### STAFF REPORT

PCA 88-D-005-08  
RZ/FDP 2014-PR-004

# 7915 JONES BRANCH DRIVE CONCEPTUAL / FINAL DEVELOPMENT PLAN

Figure 10 Landscape Plan

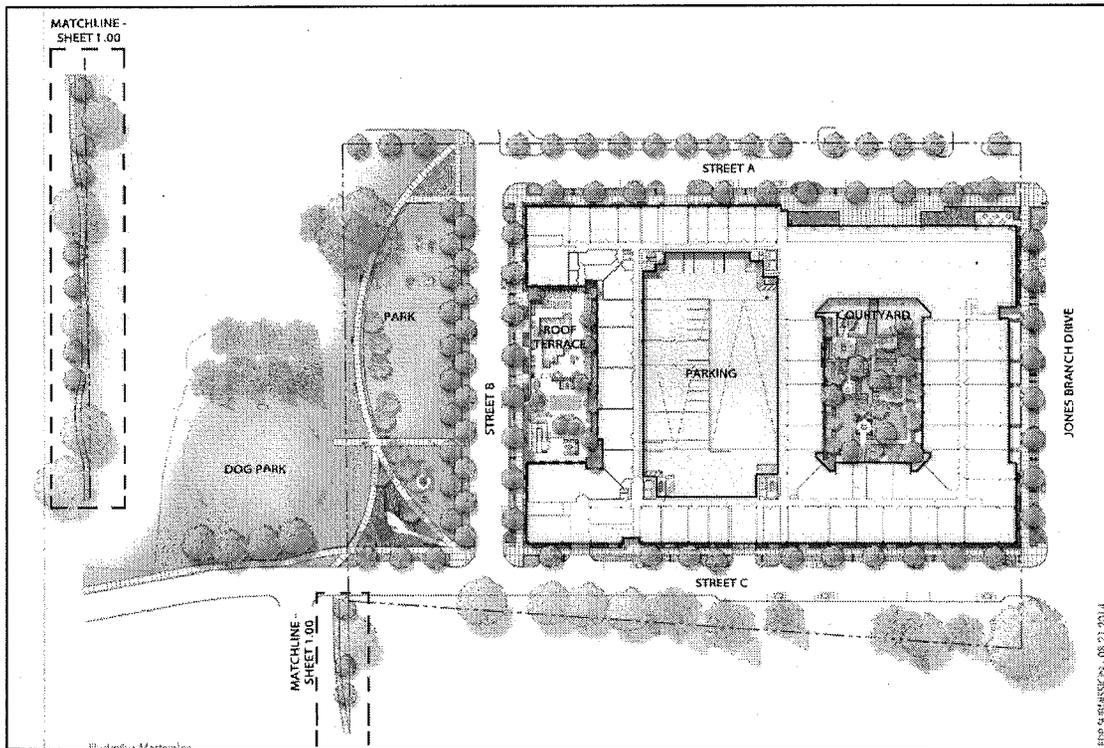
3. **Comment:** Several trees located along the 'Sidewalk Connection to Metro' are shown to be removed on sheet C-4 however, these trees are identified as 'existing trees to remain' on sheet L1.01.

**Recommendation:** The trees identified as to be removed on sheet C-4 should be clearly shown and identified as 'to be removed' on all sheets.
